**Subject: Beaver Valley Power Station, Unit No. 2  
BV-2 Docket No. 50-412, License No. NPF-73  
Order (EA-03-009) Relaxation Request**

**BEAVER VALLEY POWER STATION (BVPS) UNIT 2  
RELAXATION REQUEST from NRC Order EA-03-009**

**Alternative for Inspection of Nozzles  
That Will Provide an Acceptable Level of Quality and Safety**

Figure 1: BVPS Unit 2 CRDM Penetration Nozzle Configuration  
Outermost Penetrations (62 through 69)

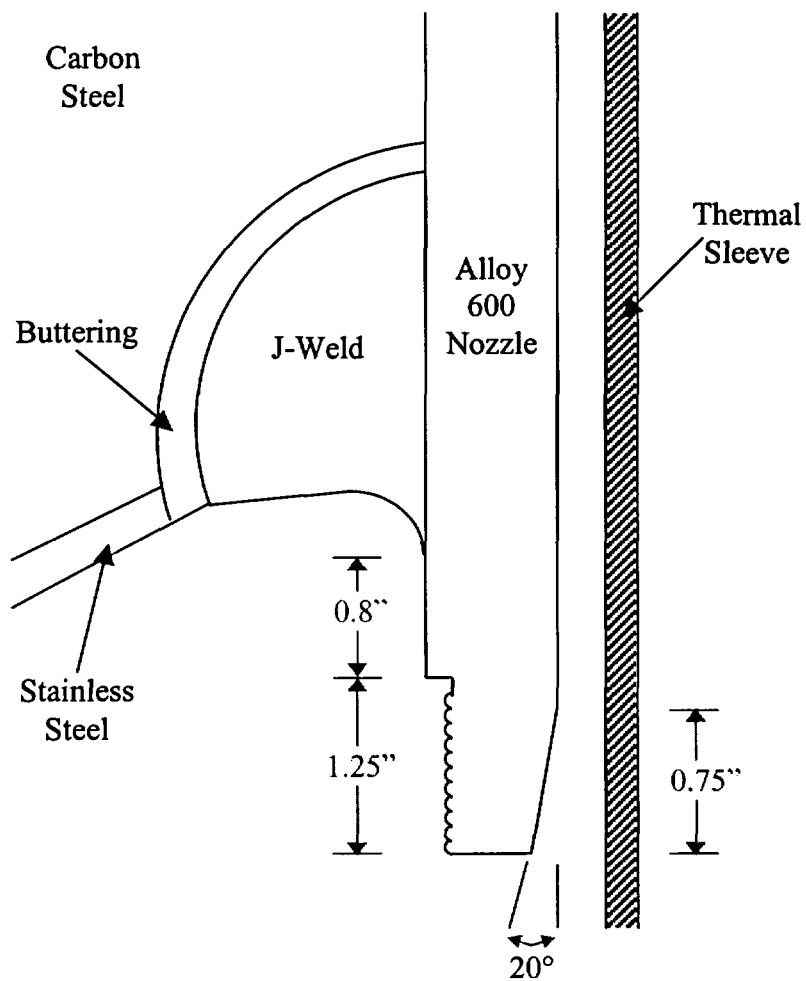
In lieu of requiring that ultrasonic or eddy current testing of each RPV head penetration nozzle extend to the bottom of the nozzle, FENOC proposes that the ultrasonic and eddy current testing conducted pursuant to Sections IV.C(2)(b)(i) and IV.C(2)(b)(ii) of NRC Order EA-03-009 be required to extend to as close as practicable to the bottom of the nozzle. On the outermost penetrations (Penetrations 62 through 69), available design information indicates that the length of tube between the bottom of the weld and the beginning of the thread relief is reduced to a minimum of 0.8" on the downhill side. On all other nozzles, the minimum distance is shown to be greater than one inch. Figure 1 shows the nozzle configuration of the outermost penetrations.

Although available design information indicate dimensions for the length of nozzle between the bottom of the weld and the beginning of the thread, our experience gained during BVPS Unit 1's inspections in the spring outage (2003) has shown that the design details concerning the extension of the weld leg down the OD of the nozzle are not absolute. For this reason, this submittal will be supplemented with field evaluation data and applicable supporting analysis to demonstrate acceptability of the unexamined portions of the nozzles.

The scope of the relaxation request involves only non-destructive examination (NDE) of the penetration nozzles below the J-groove weld. The examination coverage is expected to be a minimum of 0.8 inch on partial arcs of the outermost penetrations and greater than 1 inch in other cases, as measured from the bottom of the J-groove weld towards the bottom of the nozzle. An analysis using a flaw tolerance approach will be used to determine the significance of an axial flaw in the unexamined region of the nozzle. As stated above, this analysis will be provided in a supplemental submittal to demonstrate acceptability of the unexamined portions of the nozzles.
